The text reproduced below reflects the state of play of the discussion of the SIG UNR157 up to its 7<sup>th</sup> meeting on raising the specified maximum speed of ALKS up to 130 km/h. It is based on ECE/TRANS/WP.29/GRVA/2020/32 (DE) and subsequent amendments received on this proposal.

Modifications to the existing text of UN-Regulation No. 157 (incl. suppl. 02 to 00 series) are marked in **black bold** for new or ~~strikethrough~~ for deleted characters.

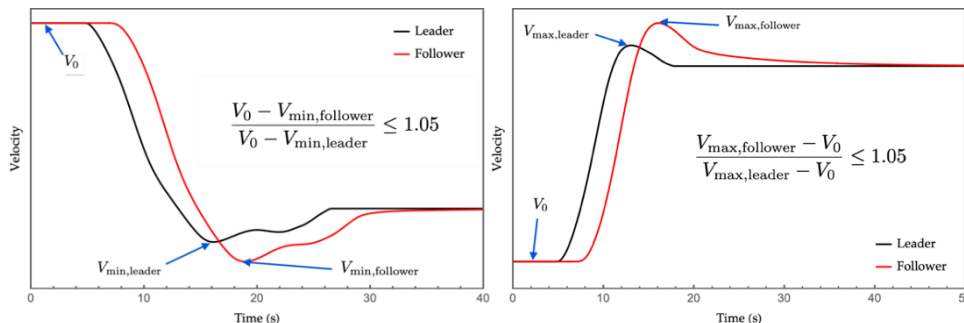
*Point of discussion on 5.2.9. and 5.2.10: Agreement to include some aspects of proposals from JRC/EC (UNR157-03-06) on “string stability” as general requirements. Leadership to prepare proposal. → Group needs to review proposal by leadership.*

**[5.2.10 While following another vehicle the ALKS vehicle shall aim to be string stable.**

**In particular, when following another vehicle at constant speed and at a distance such that the speed profile of the ALKS vehicle is influenced by the speed profile of the vehicle in front, the ALKS vehicle shall aim to respond to a perturbation in the speed of the vehicle in front with a perturbation in its speed profile by at most a 5% increase in the maximum difference in speed compared to the vehicle in front before reaching a new equilibrium velocity following the visual examples reported in the following figures.**

**In addition, in the case when there is more than one ALKS vehicle in a chain following a vehicle under the conditions described in the previous paragraph, they shall aim to avoid further amplifying the perturbation caused by the lead vehicle from one vehicle to the next. The provisions included in this paragraph shall be demonstrated in accordance with Annex 4 of this Regulation.]**

Figure 1  
~~Skilled~~ Careful and competent human performance model

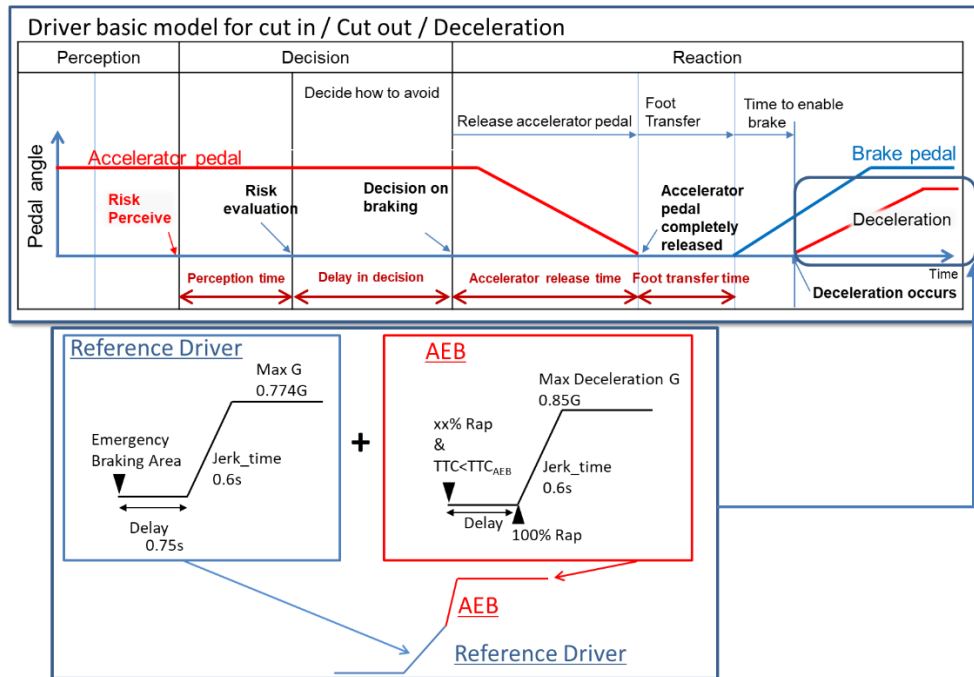
***Points of discussion for Annex 3: Proposal by leadership to implement the tentative group decision from 7<sup>th</sup> SIG to embrace the JRC/EC model in Annex 3 as guidance (largely transferred from JRC/EC proposal UNR157-03-06)). Group needs to confirm, if this proposal is acceptable.***

- 3.3. **“Performance model 1”**
  - 3.3.1. **In the first performance model**, the avoidance capability of the driver model is assumed to be only by braking. The driver model is separated into the following three segments: "Perception"; "Decision"; and, "Reaction". ~~The following~~ diagram **in Figure 1** is a visual representation of these segments.÷

- 3.3.1.1. To determine conditions under which Automated Lane Keeping Systems (ALKS) shall avoid a collision, performance model factors for these three segments in ~~the following~~ **Table 1 table** should be used as the performance model of ALKS considering attentive human drivers’ behavior with ADAS.

**Figure 6**  
**Flow-chart of the second ALKS performance model for the case of the cut in traffic critical scenario**

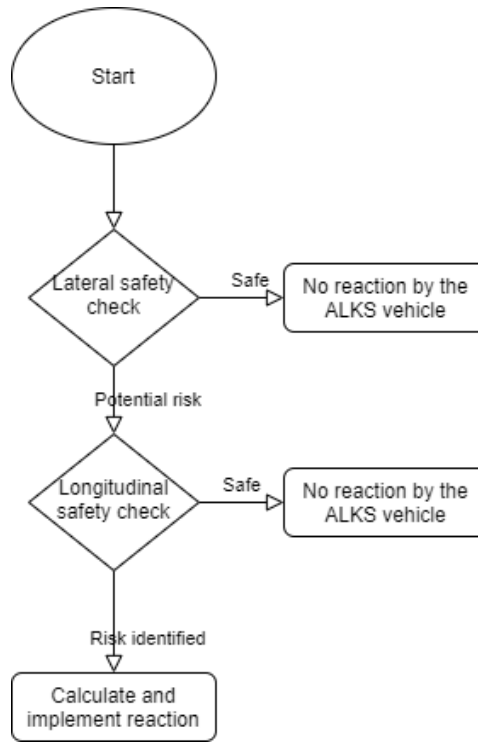
3.4.1. In the second performance model, it is assumed that the driver can apply proportionate braking actions in order to anticipate the risk of collision. In this case, the performance model considers the following three actions performed by the competent and careful human driver: "Lateral Safety Check"; "Longitudinal Safety Check"; and, "Reaction". A Reaction is implemented only if the Lateral and Longitudinal Safety Checks identify a risk of imminent collision. The diagram reported in Figure 2 provides a visual representation of the decision flow followed by the driver in the second performance model for the case of the cut-in traffic critical scenario.
